## WORK PLAN COMMENTS

The correct BRRTS number: 02-13-583366

Figure 3. Pearson Street/East Burn Pit Sample Locations.

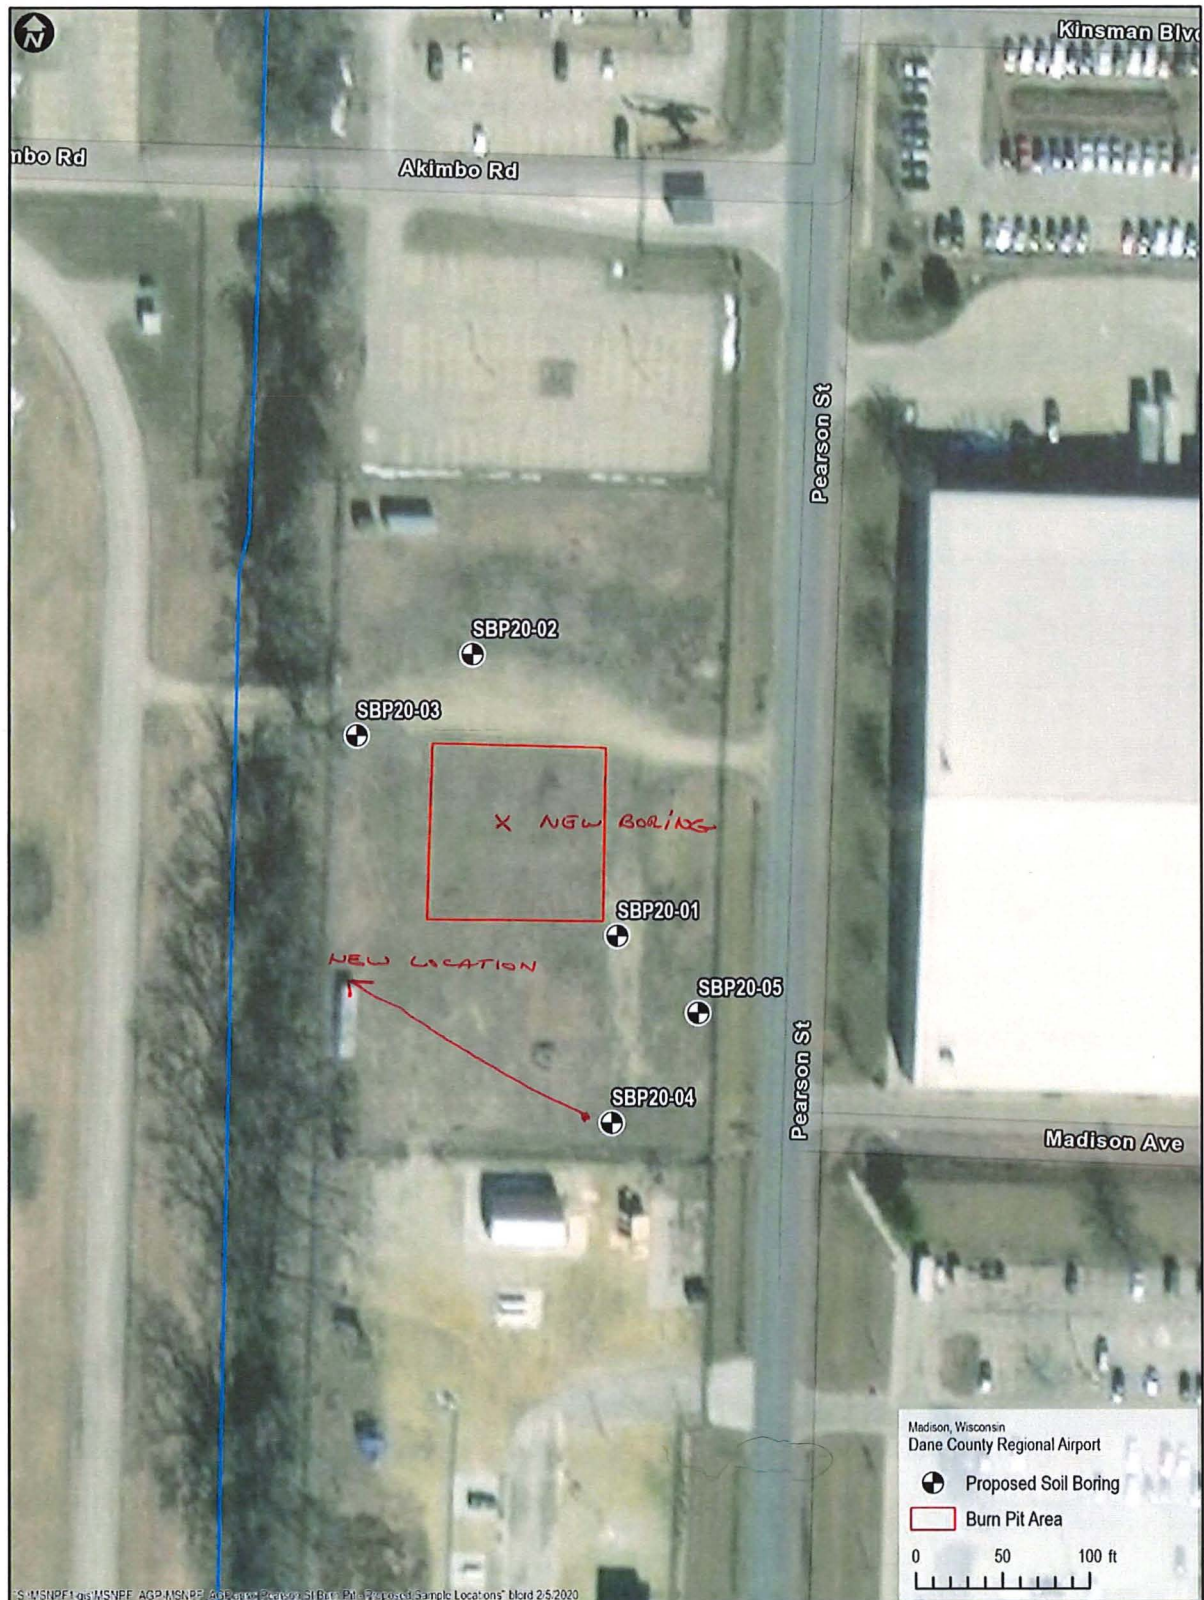
Change one boring location at each burn pit (See attached)

Add one boring location at each burn pit (See attached)

Change proposed sample depth at East Burn Pit to:

1-2 feet below ground surface

At the water table, as proposed

The East Burn Pit may have had past soil handling activities
